DRAFT RESPONSE TO TASK INTERFACE AGREEMENT
2014-05 RELATED TO DESIGN BASES AND LICENSING
BASIS FOR UNDERGROUND CABLE
CONFIGURATIONS AT OCONEE
NUCLEAR POWER STATION. UNITS 1, 2, AND 3

Cable Shield and Armor in Power Cables

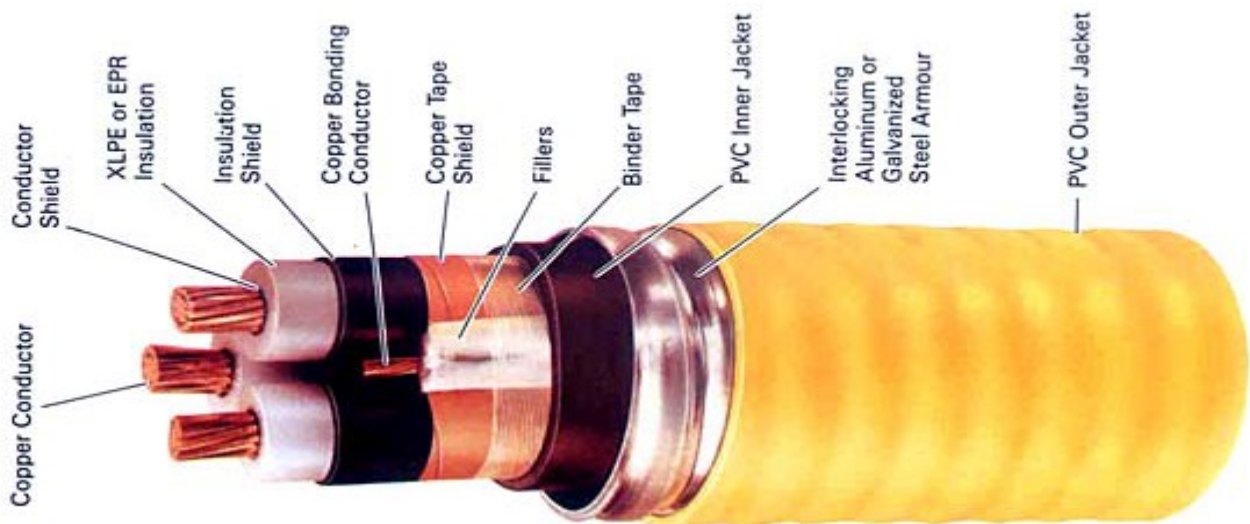
Question 2J: Can cable shielding or armor prevent short circuits or limit faulted currents and voltages?

- Can the two wraps of bronze shielding tape in the licensee's current power cable configuration be considered equivalent to the steel interlocked armored cable as described in the test report MCM-1354.00-0029.001?
- Are the results of test report MCM-1354.00-0029.001 sufficient to demonstrate that electrical faults cannot propagate from one cable to another as described in the single failure DBD, Section 3.3.6.1?

Response 2J: No. Both Cable shielding and Armor cannot be credited for preventing short circuits or limiting fault currents and voltages. Cable shielding and cable armor serve different functions. A shield is employed in the subject cable design to preclude excessive voltage stress on voids between the conductor and insulation, and to confine the electric field of the cable to the insulation of the conductor or conductors.
